**1 2 3 ALTERATION NUMBER FOR SUBJECT APPLICATION**

PL2	20/10/2021	GS	RL	PK	ISSUED FOR PLANNING ALTERATIONS
Rev	Date	By	CHK	App	Reason
Drawing Title: <b>PLANNING ALTERATIONS</b>					
Job Title: <b>INDUSTRIAL DEVELOPMENT AT TAY LANE, GREENOGUE, RATHCOOLE, Co. DUBLIN</b>					
Drawing Title: <b>BLOCK A - LIGHT INDUSTRIAL UNIT &amp; ANCILLARY OFFICE/STAFF FACILITIES SECTIONS</b>					
Author/Dept: <b>ELECTRICAL WASTE MANAGEMENT LTD.</b>					
Consulting Engineers: <b>KAVANAGH BURKE CONSULTING ENGINEERS</b>					
Tel: 01-450 0694		Unit F3, Calmount Pk.		Ballymount, Dublin 12.	
Fax: 01-426 4340		Email: pkavanagh@kavanaghburke.ie			
On: GS	Checked: RL	Approved: PK			
Scale: 1:100 (B/A1)	Date: NOVEMBER 2021				
Job No: D1541	Drawing No: GA-A-A03	Rev: PL2

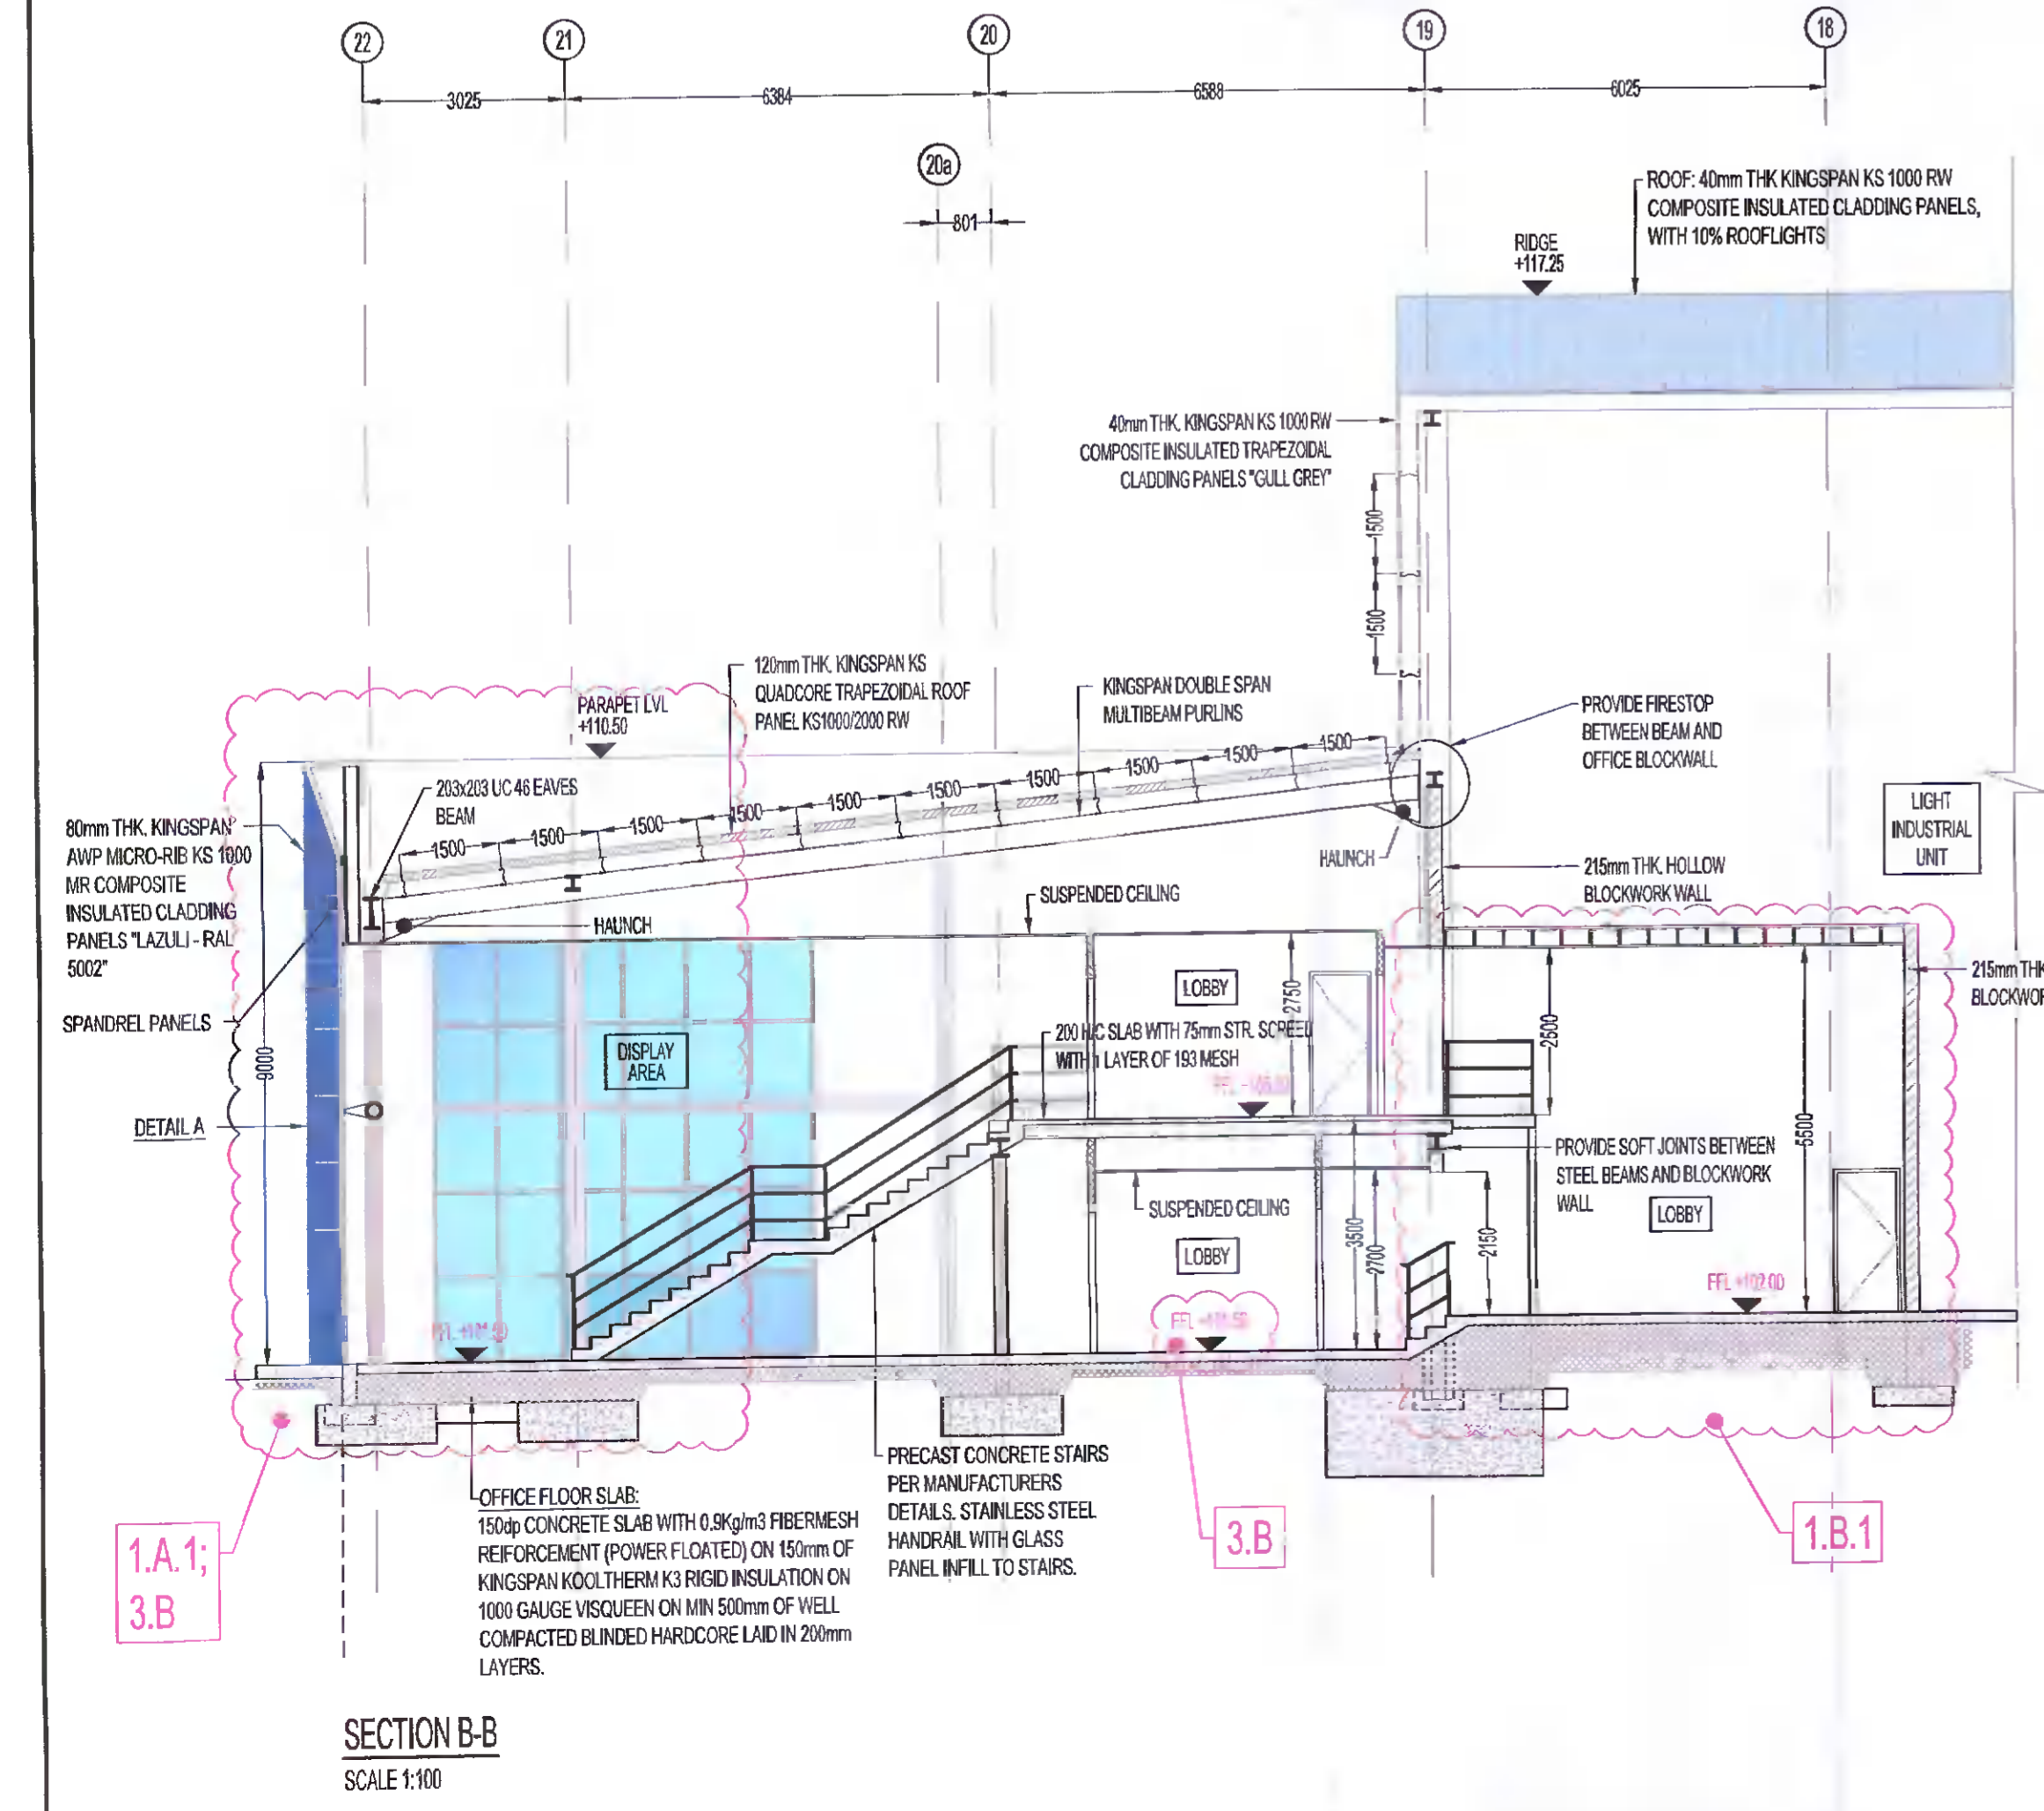
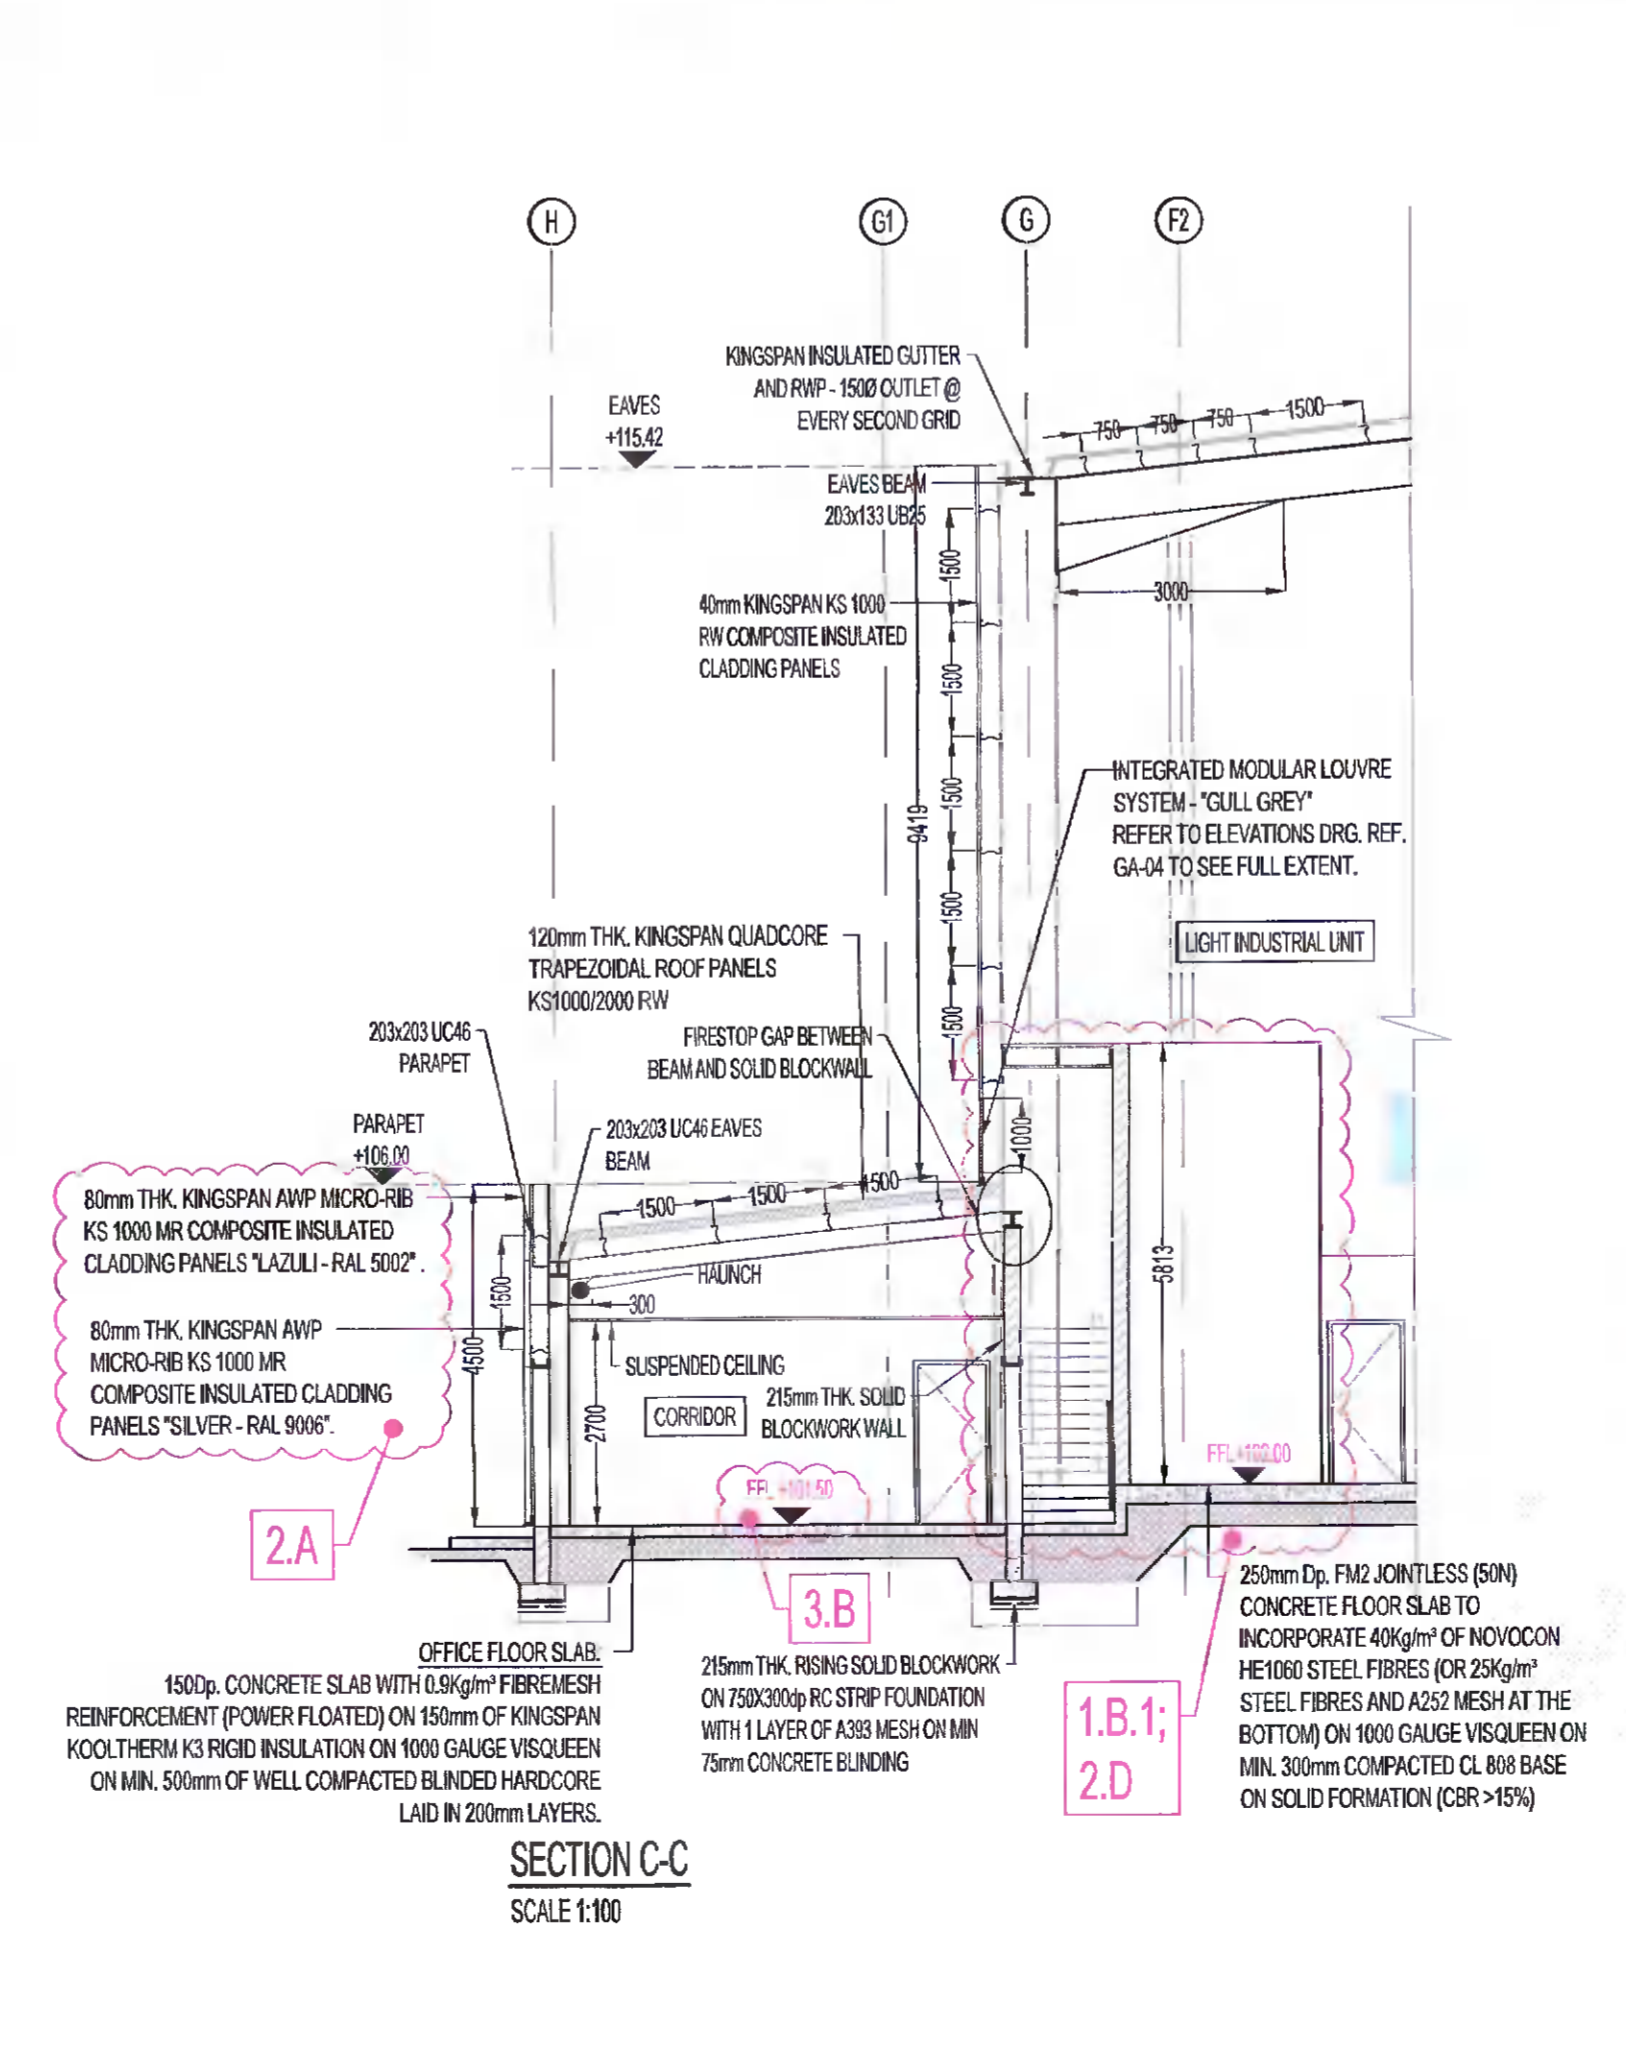
- RECONFIGURATION OF THE FLOOR PLAN AREAS AS FOLLOWS:**
  - A. Provision of 535m<sup>2</sup> additional floor area due to introduction of areas as follows:

- A.1. Extended display area at ground floor of ancillary Office, addition of 42m<sup>2</sup> floor area;
    - A.2. Extended open plan office at first floor of ancillary office, addition of 22m<sup>2</sup> floor area;

- A.3. Single storey ancillary storage facility to the front north-east elevation, totalling 166m<sup>2</sup>, overall height 7m;
    - A.4. Mezzanine area to the south eastern side of Light Industrial Unit, totalling 303m<sup>2</sup>;
 Alterations listed above result in total building area increase from 4361m<sup>2</sup> to 4926m<sup>2</sup>, as shown at the revised table of gross internal floor areas & uses.

- B. Change of use of 64m<sup>2</sup> of Light Ind. Unit floor area to staff facilities due to the introduction of:
    - B.1. Enclosed stairs from Light Industrial Unit to ancillary Office/Staff facilities (overall 31m<sup>2</sup>);

- B.2. Single storey cleaners store and storage at ground floor to the north-eastern corner of Light Industrial Unit (overall 33m<sup>2</sup>);
  - C. Change of use of 100m<sup>2</sup> of workshop charging area & staff facilities to workshop area & single storey office/staff facilities;

- D. Introduction of full height dividing wall at Light Industrial Unit.
- ELEVATIONS ALTERATIONS AS PER LIST ABOVE PLUS ADDITIONAL ALTERATIONS AS FOLLOWS:**

- A. Provision of full height cladding (ground floor to roof) to Light Industrial Unit and ancillary Workshop;
  - B. Introduction of 11m wide x 6m high open to Light Industrial Unit side (north-western) elevation;

- C. Rearrangement of all fire exit & level access doors to Light Industrial Unit & ancillary Workshop, including omission and addition of the same;
  - D. Introduction of integrated modular louvre system to Light Industrial Unit rear (south-western) & side (north-western) elevation;

- E. Introduction of canopies to the ancillary Office main entrance and above 11m wide open & dock levelers to Light Industrial Unit side (north-western) elevation.
